DATE: 10.08.2018
TO: ProTrak
FROM: Mitesh Baxi
Traffic Engineering

■ **CALIBRATION STATION OFFICES [TRC Plan Review #3]**

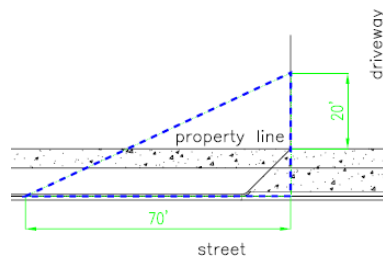
1. Site plan shows the handicap ramp at the end of proposed public sidewalk at intersection of Southern Blv and Virginia Ave. Demonstrate the route/s, these ramps will be leading to.
2. The City's 20'x70' sight distance triangle is not implemented correctly. Revise as per below image. Show the City's 46'x46' sight distance triangle at each street corner intersection abutting this property. [\[Sec.18-529\(c\)\(3\)CofW LDC\]](#) Add a note indicating that all proposed vegetation within sight triangles shall not interfere with clear visual sight lines from 30"-10'. [\[Sec.18-556 CofW LDC\]](#)
